HYDROLOGY D17/D42 LOT 29A INTERSTATE INDUSTRIAL

GRADING AND DRAINAGE PLAN
FOR
LOT 29-A
OF INTERSTATE INDUSTRIAL TRACT-UNIT IV
FILED MAY 7, 1979 RECORDED VOL.D9 FOL.119

Revised 9/8/82

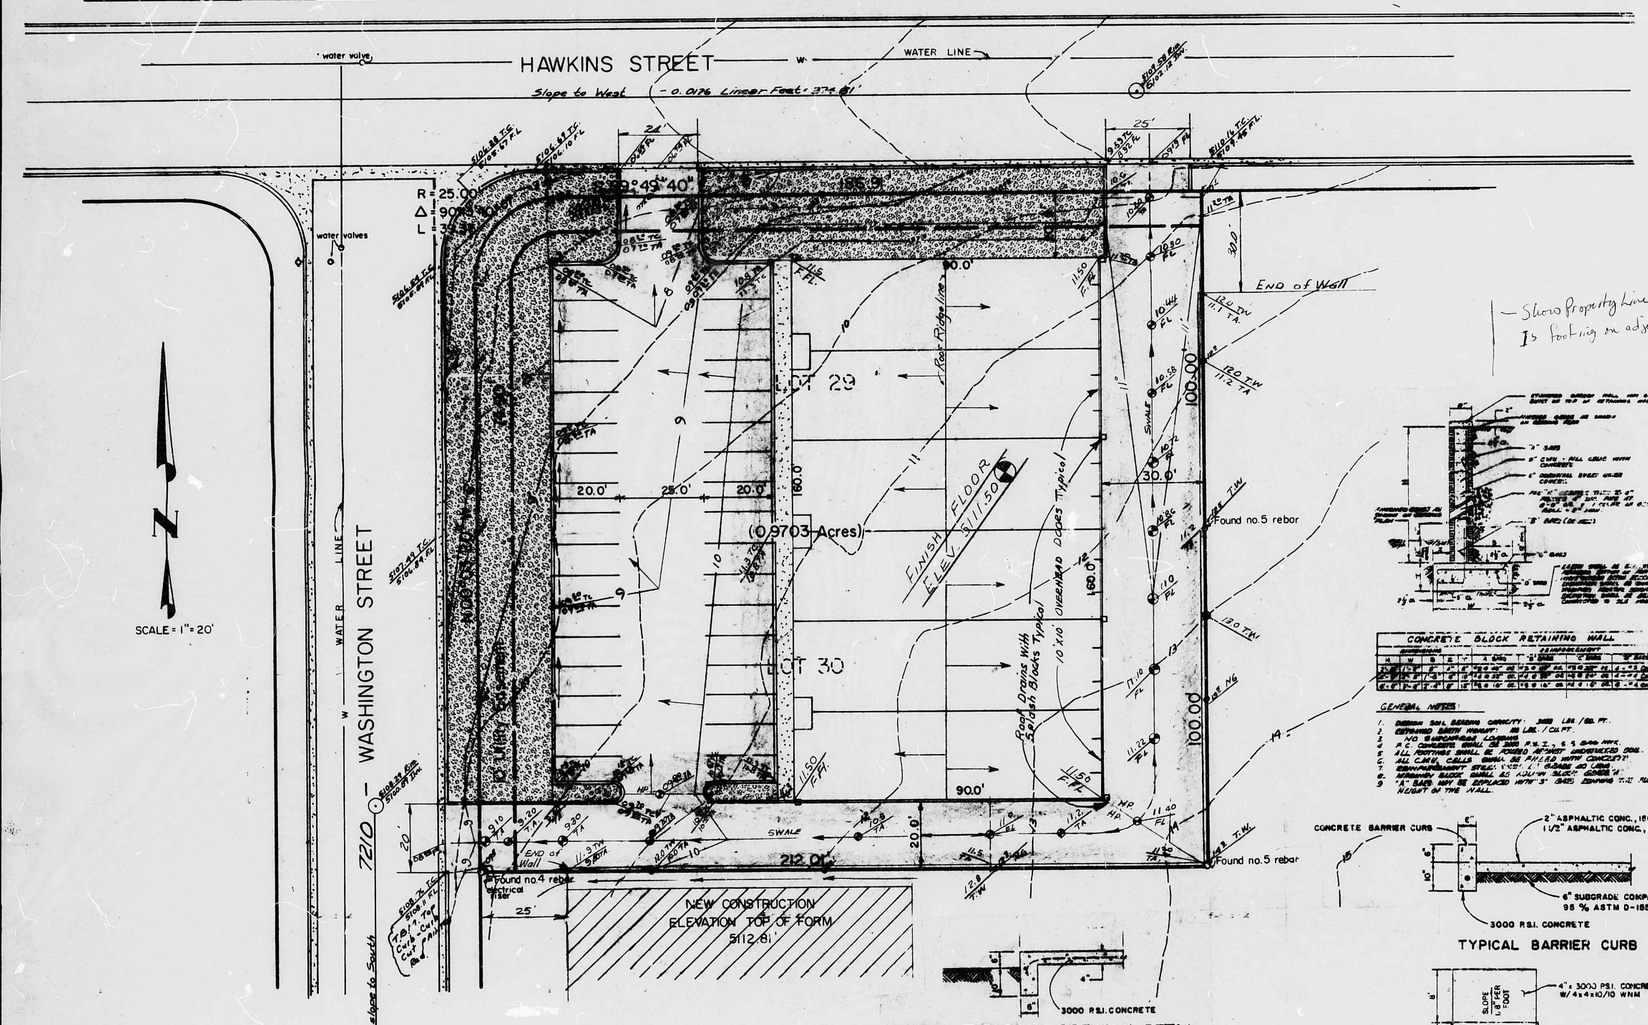
— Show Property Line, Is footing on adjoining Property?
